Docket Number:	12-AFC-02
Project Title:	Huntington Beach Energy Project
TN #:	202632
Document Title:	Applicant's Submittal of Correspondence re Air Quality
Description:	N/A
Filer:	Kimberly Hellwig
Organization:	Stoel Rives LLP
Submitter Role:	Applicant
Submission Date:	6/30/2014 11:28:22 AM
Docketed Date:	6/30/2014

Subject: Huntington Beach Energy Project (HBEP)
Preliminary Determination of Compliance, Response to Comments

Subject: Huntington Beach Energy Project (HBEP)
Preliminary Determination of Compliance, Response to Comments

Subject: Huntington Beach Energy Project (HBEP)
Preliminary Determination of Compliance, Response to Comments

Figure 1. Annual Arithmetic Mean PM10 Particulate Matter ($\mu\text{g}/\text{m}^3$) in 2011.

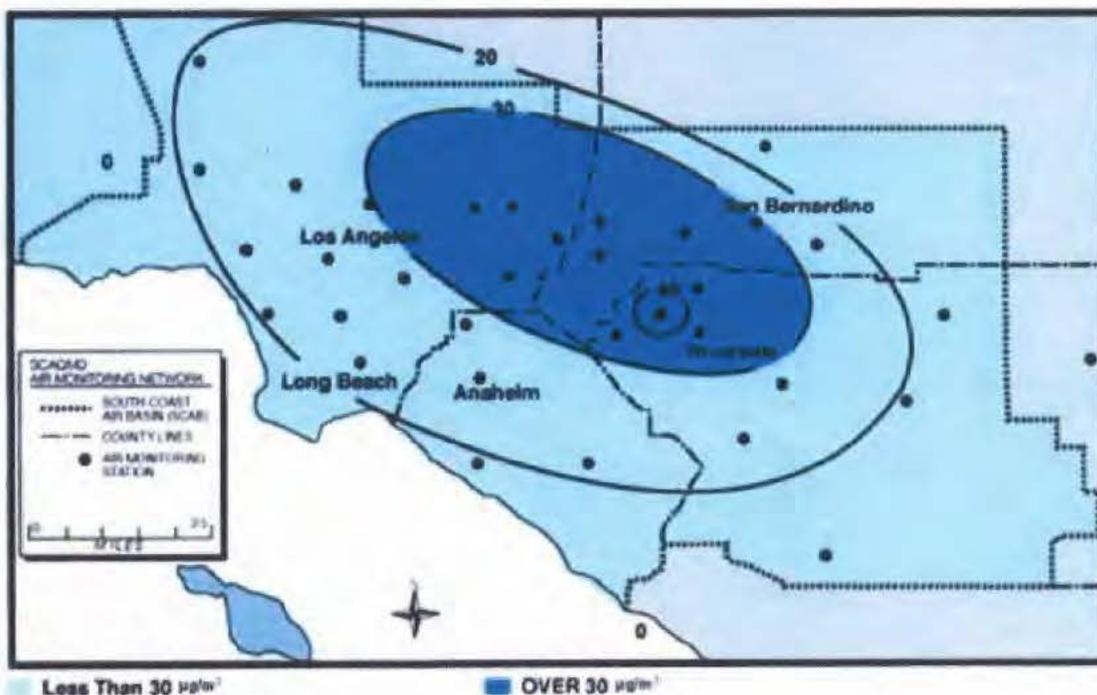
Your comment centers around the issue of the actual PM10 emissions from the existing plant as compared to the new plant's potential to emit (PTE), and the health effects of the particulate emissions.

While a comparison of the actual emissions to potential to emit (PTE) will almost always show that the new plant has a larger PTE than the old plant's actual emissions, in reality the extent to which the new plant will actually operate is somewhat uncertain. Generally, a plant operator will wish to permit the project at a high enough level to allow flexibility in its operation and to avoid a situation where the plant has to cease operation because of permit restrictions. This may be the operator's 'worst case' emission scenario. However, page 13 of the PDOC states that the plant operator has estimated that the actual operating time of the plant would be between 35-50% on an annual basis. And although the actual emissions from the new plant may still be higher than the actual emissions from the existing plant, the new plant will be more efficient meaning it generates the same amount of electricity while burning less fuel than the existing utility boilers. Also, the actual emissions may be a fraction of the PTE.

Furthermore, the PM10 and PM2.5 air quality of coastal Orange County (i.e., area of the proposed project) is among the cleanest regions in the four-county jurisdictional area of the SCAQMD; see Figures 1 through 3, which are taken from the 2012 Air Quality Management Plan (<http://www.aqmd.gov/aqmp/2012aqmp/index.htm>). As shown in Figure 1, the annual PM10 air quality is well below the old annual National Ambient Air Quality Standard (NAAQS) of 50 mg/m³ (The annual PM10 NAAQS was revoked in 2006). The whole four-county jurisdictional area (including coastal Orange County) currently meets the 24-hour PM10 NAAQS of 150 mg/m³. As shown in Figures 2 and 3, the PM2.5 air quality along coastal Orange County is below the 24-hour and annual NAAQS of 35 mg/m³ and 12 mg/m³, respectively. It is anticipated that the Huntington Beach area will continue to have some of the cleanest air quality levels amongst the four-county jurisdictional area of the SCAQMD even with the development of the Huntington Beach Energy Project.

Figure 4. Model-estimated inhalation cancer risk for MATES III (2005 time period).

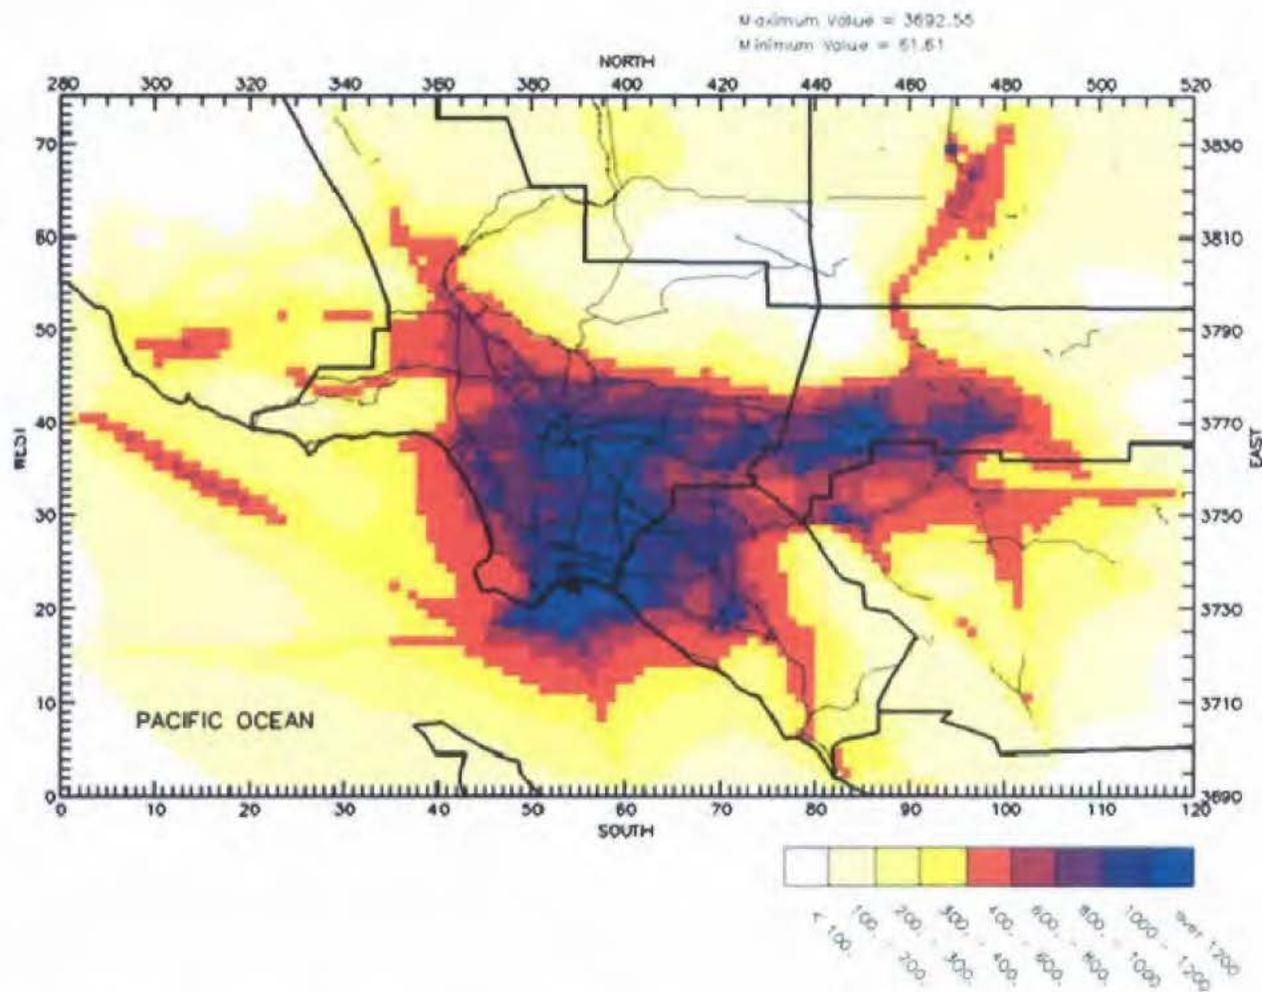
Your comment pertains to the health effects of the project on long-term residents living in the area.

While the health risk assessment does not go back retrospectively and evaluate previous health impacts to long-term residents, cancer risks from the project assume that individuals are exposed to the project's emissions continuously (except for two weeks each year) from birth through 70 years old. Potential cancer risks less than 10 in a million and non-cancer impacts less than a hazard index of one are considered in compliance with applicable rules and regulations. The peak cancer risk impacts from the AES Huntington Beach Energy Project are 2.4 in a million and the non-cancer chronic and acute hazard indices are 0.008 and 0.069, respectively, which are well within the rule requirement of District Rule 1401. Also, these impacts are conservative since there are associated emission decreases with the shut-down of boiler units 1 and 2, which are not addressed in the analysis.

It should be noted that coastal Orange County, the site of the project, has some of the lowest inhalation cancer risks in the jurisdictional area of the SCAQMD as shown in Figure 4, which was taken from the Multiple Air Toxics Exposure Study (MATES) III report (<http://www.aqmd.gov/prdas/matesIII/matesIII.html>). MATES IV reports are currently under development and should be available in the summer of 2014. Coastal Orange County will continue to have some of the lowest inhalation cancer risks in SCAQMD's jurisdictional area.
